Contributions on A-LCA SG4 activities

prepared by JPN

A-LCA SG4 Meeting on 21st September, 2023

List of Topics and proposals :

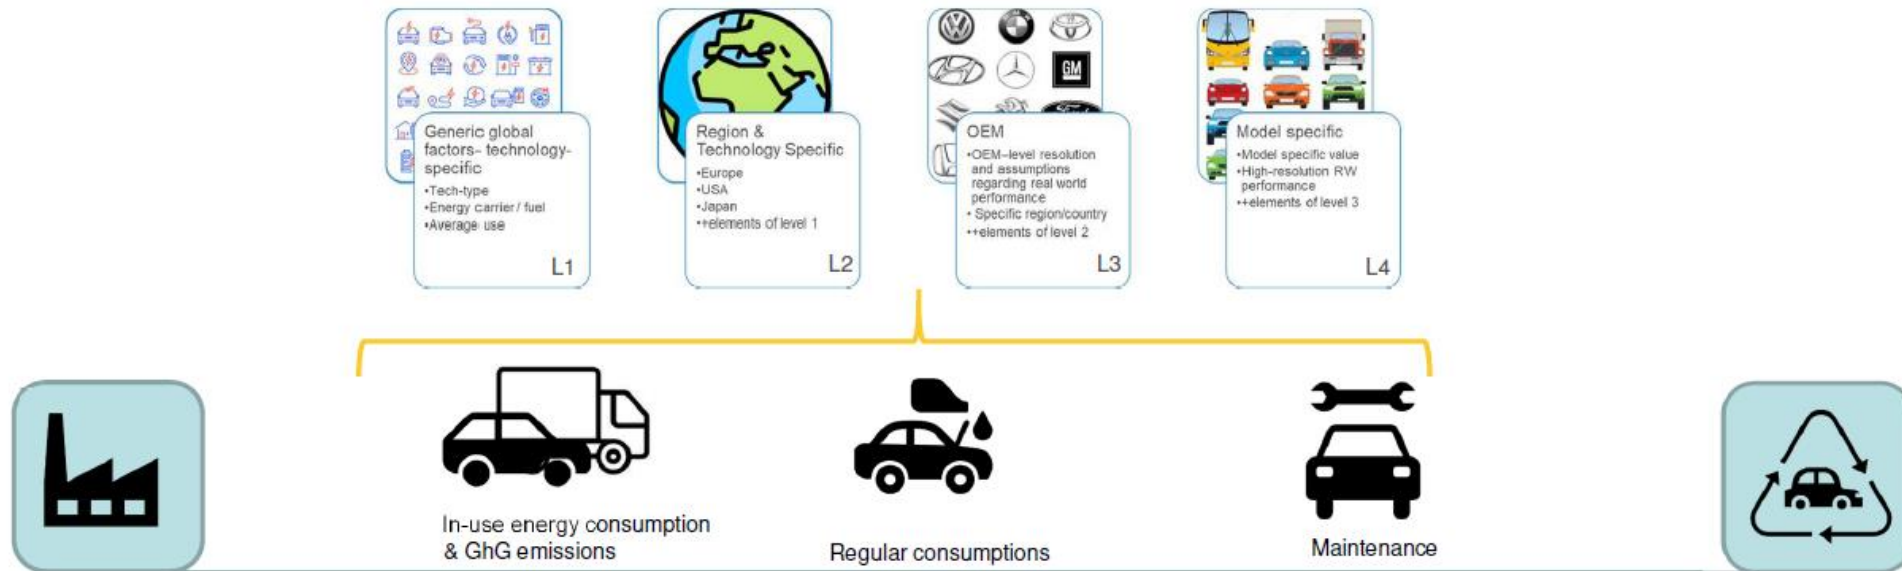
no interest according to ToR purpose

later stage due to current tolerance and data unavailability in JPN

later stage
← better to follow EVE IWG discussion

SG4 Boundaries

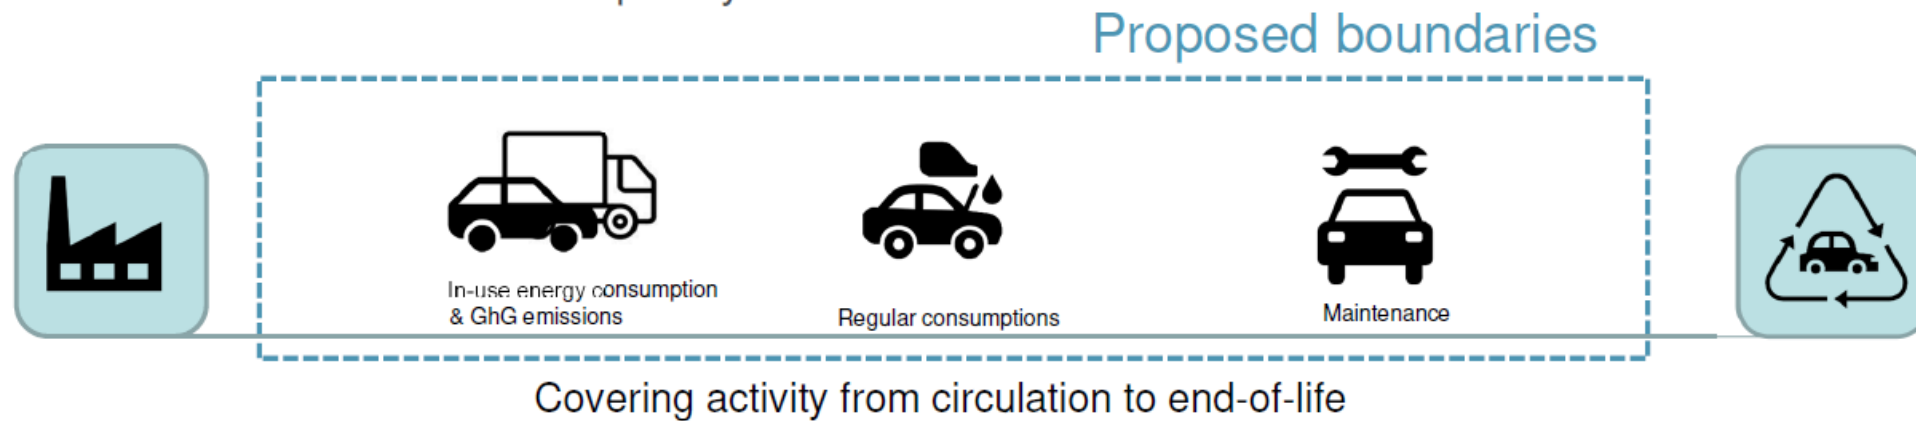
fully support !!

- ✓ no need to consider product deliver to user in all phases (but flexible per further discussion)
- ✓ OK to accept SG3 request (dealer showcase), but it's out of consideration
- ✓ “maintenance” include also disposal phase

Draft CO₂eq Calculation (JRC)**

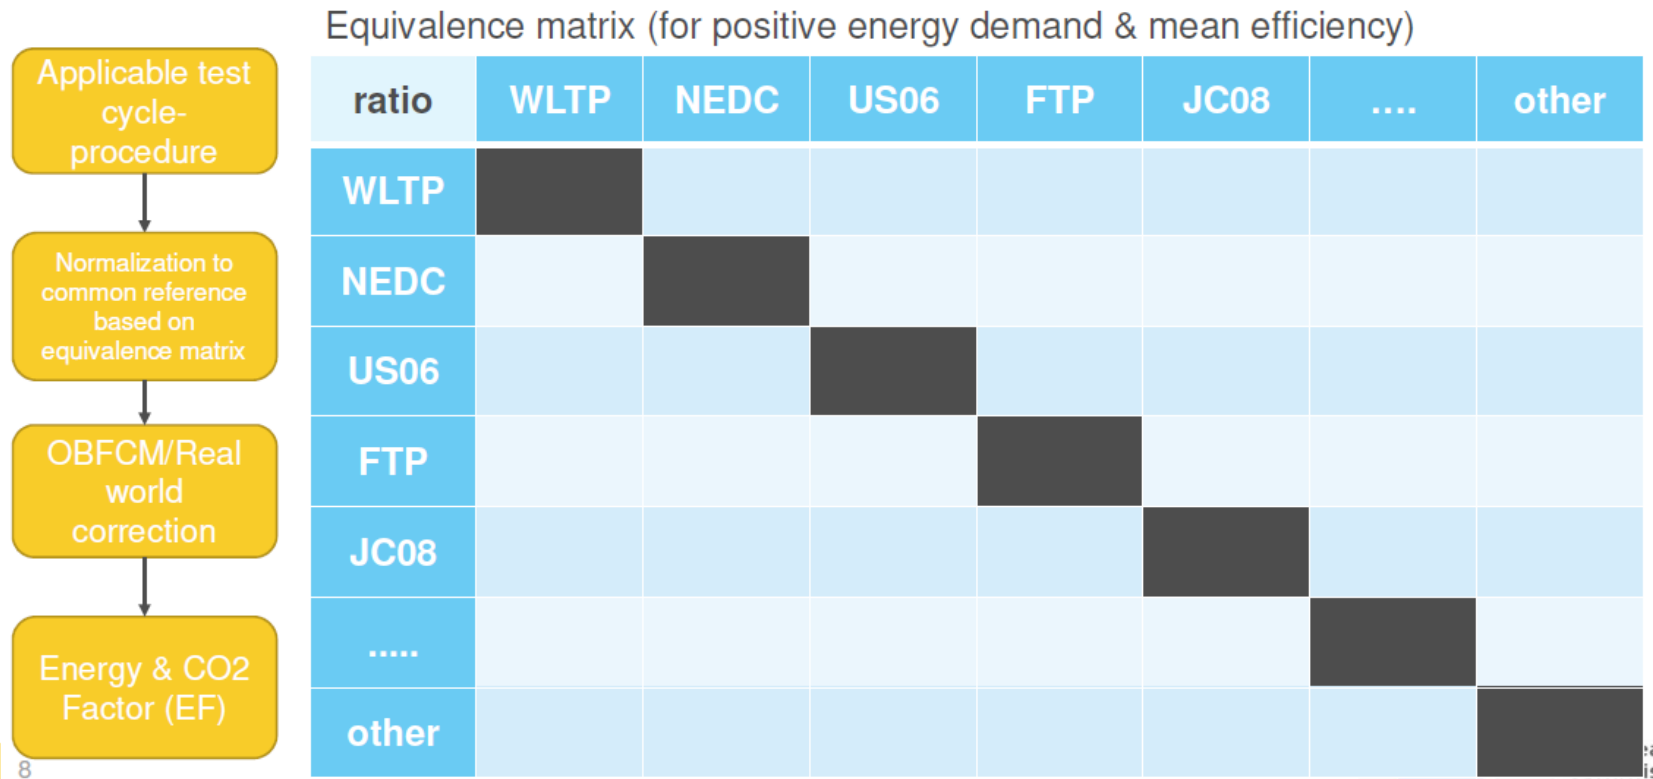
Fuel energy consumption for OVC-HEV is only parameter to be considered, but it's up to the impact (JPN has no data)

No proposal from JPN side

** Important to define levelling concept [lvl1, lvl2, lvl 3, lvl 4] and the data sources

JPN sees that no levelling concept is necessary for SG4
